# CITY OF ALBUQUERQUE

RE: **Lot 8 Block 4 Unit 19 Volcano Cliffs**  
**6528 Azar NW**  
**Grading and Drainage Plan**  
**Engineers Stamp Date 9/16/14 (D10D003T8)**

Based upon the information provided in your submittal received 2/27/15, this plan is approved for Grading Permit and Building Permit.

PROJECT NO: 0840010400  
DESIGNED BY:  
DRAWN BY:  
CHECKED BY:  
DATE: SEPTEMBER 2014  
SHEET TITLE  
LEGAT DESCRIPTION  
LOT 8, BLOCK 4  
VOLCANO CLIFFS  
SUBDIVISION  
UNIT 19

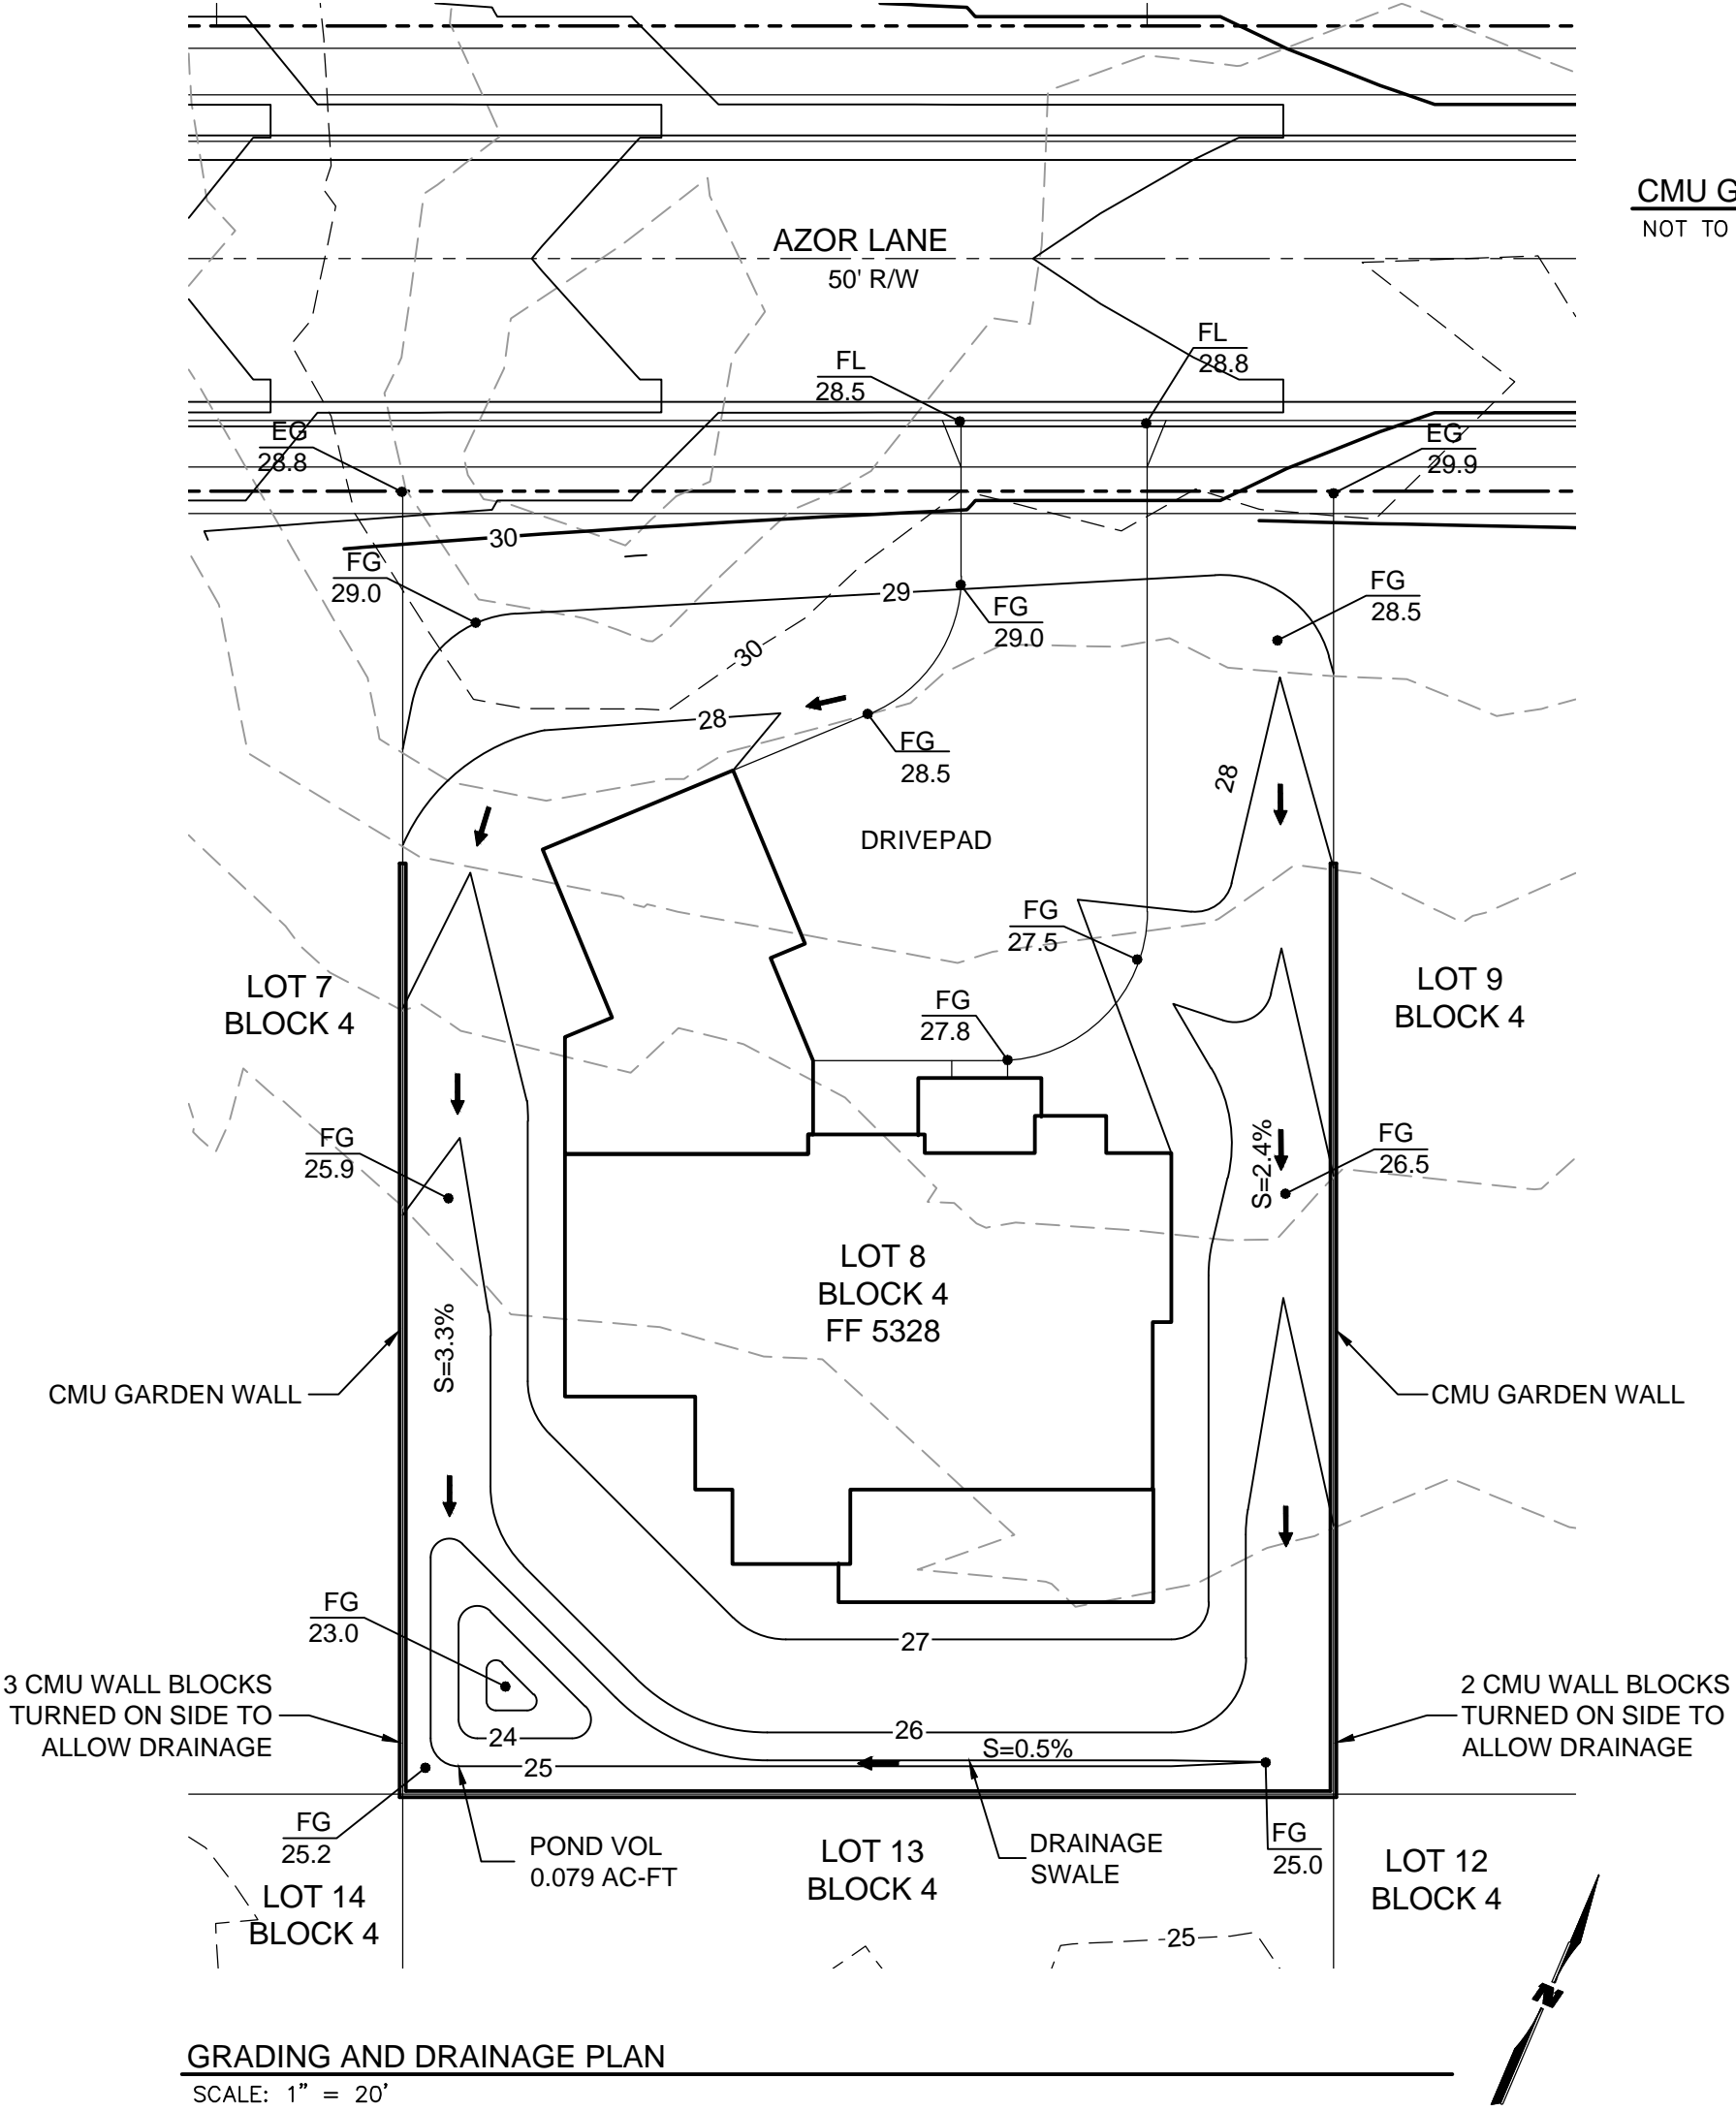
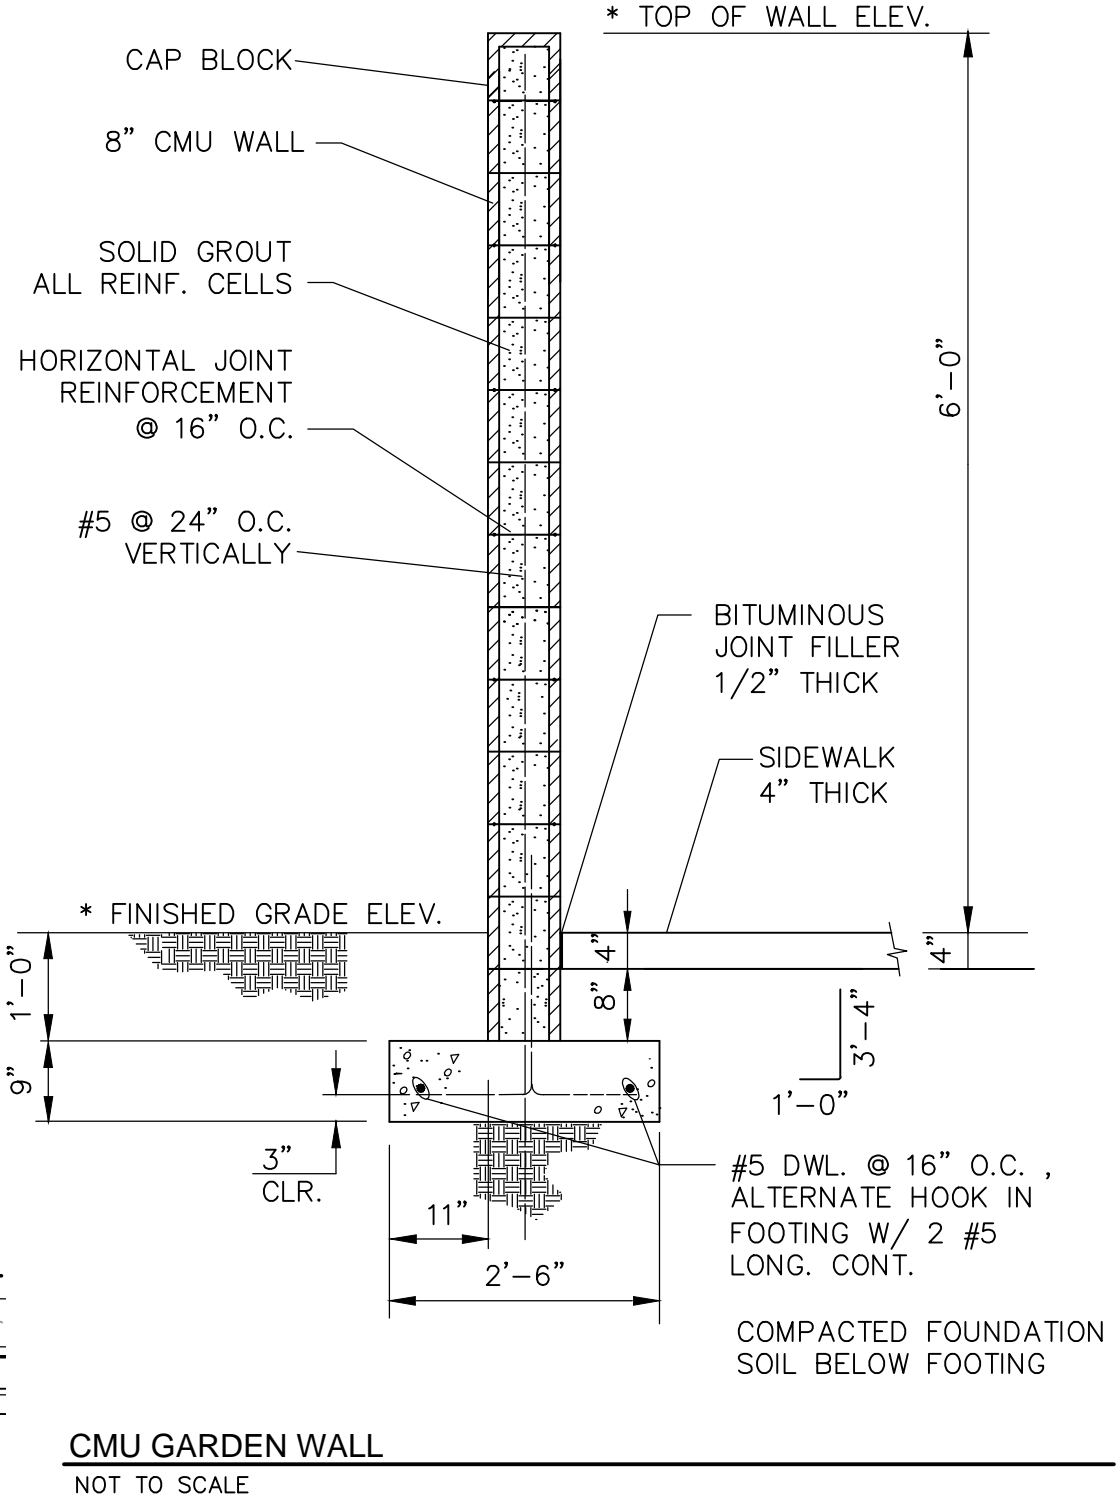
Please attach a copy of this approved plan to the construction sets in the permitting process prior to sign-off by Hydrology.

Prior to Certificate of Occupancy release, Engineer Certification per the DPM checklist will be required.
